Access Compliance Report

Public Rights-of-Way

Intersection ID: 10027413	Main Street: GOLF_LINKS_DR_N	Cross Street: N/A	Location: NE
ADA ID: 589588951A3A	Ramp Type: BlendTrans1	Initial Pass/Fail: Fail	Overall Compliance: No
Severity Score: 10			
Codes/Mitigation Info/Possible Solution		Field Measurements/Component Compliance

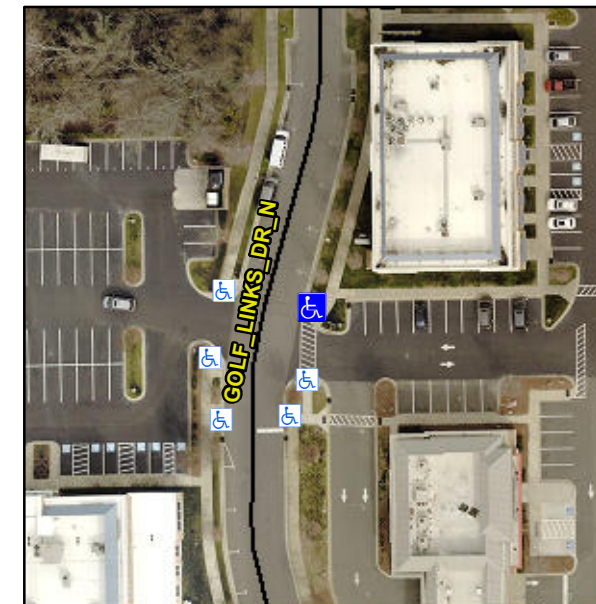
Not Found, R304.5.1, R304.5.3

Compliance	Description	Data	Compliance	Description	Data
N/A	Ramp Length (in)	56.0	Yes	BlendTrans Slope (%)	2.0
No	Ramp Width (in)	40.0	No	BlendTrans XSlope (%)	2.3
N/A	Flare Type LT	N/A	N/A	Flare Type RT	N/A
N/A	Flare Slope LT (%)	N/A	N/A	Flare Slope RT (%)	N/A
N/A	Flare Traversable LT?	N/A	N/A	Flare Traversable RT?	N/A
N/A	Landing Length (in)	N/A	N/A	DWS Provided?	N/A
N/A	Landing Width (in)	N/A	N/A	DWS Contrast?	N/A
N/A	Landing Slope (%)	N/A	N/A	DWS Length (in)	N/A
N/A	Landing X Slope (%)	N/A	N/A	DWS Full Width?	N/A
N/A	Landing Curb? (Y/N)	N/A	N/A	DWS Offset (in)	N/A
N/A	Shared Landing?	N/A			
N/A	Gutter Ponding?	N/A	N/A	Gutter Slope (%)	N/A
N/A	Gutter Lip Ht (in)	N/A	N/A	Gutter X Slope (%)	N/A
N/A	Painted X Walk1?	No	N/A	Painted X Walk2?	Yes
	X Walk 1 Direction	To W		X Walk 2 Direction	To S
	X Walk 1 Width (in)	N/A		X Walk 2 Width (in)	89.0
	X Walk 1 Slope (%)	0.8		X Walk 2 Slope (%)	0.3
	X Walk 1 X Slope (%)	2.4		X Walk 2 X Slope (%)	0.3

N/A	Ramp inside XWalk1?	N/A	N/A	Ramp inside XWalk2?	Yes
	Road Slope (%)	0.2		Clear Space?	N/A
	Road X Slope (%)	0.1	N/A	Clear Space to XWalk (in)	N/A
N/A	Any Obstructions?	N/A	N/A	Storm Grate/Utility Hazard?	N/A
	Obstruction Type			Storm Grate/Utility Type	
		N/A			N/A
			Yes	Surface Condition? (G/P)	Good
			No	Curb Slope (%)	8.2

Remove & Replace Curb Ramp With Two New Directional Ramps or Equivalent.
